**FINAL DRAINAGE REPORT**  
for  
**OWL MARKETPLACE FILNG NO. 1**

Falcon, Colorado

**March 2024**

El Paso County File No. VR2321

Figure 9-45. UDFCD modified USBR type VI impacts stilling basin (general design dimensions)

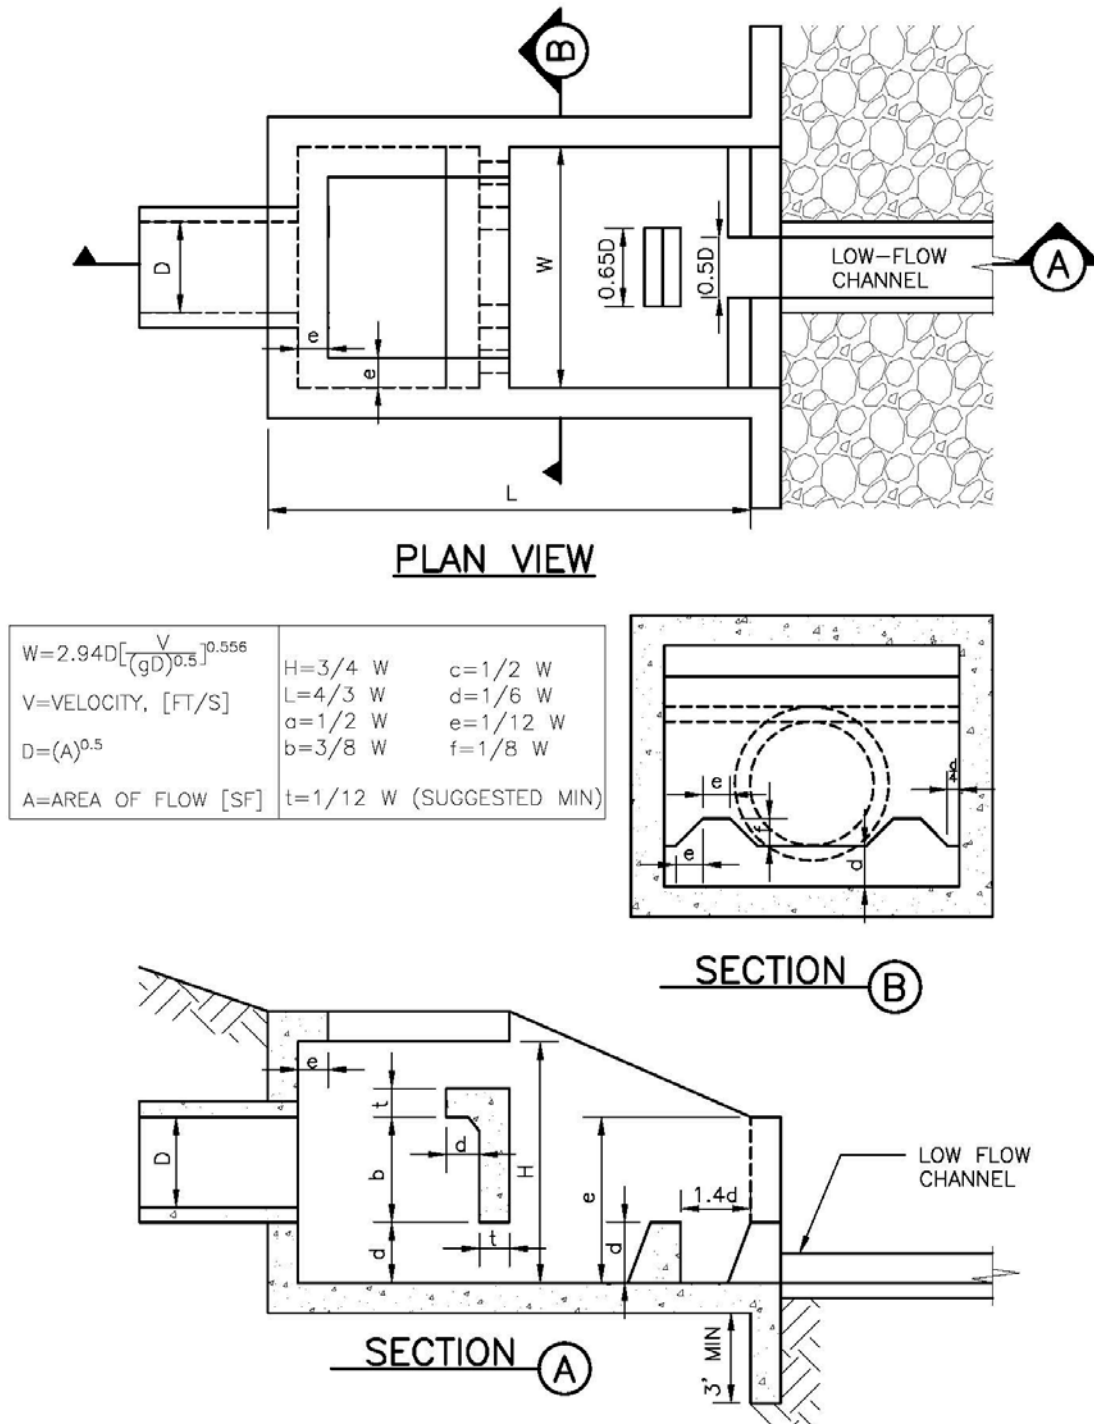
This min notch width is not met on the forebay detail on CDs
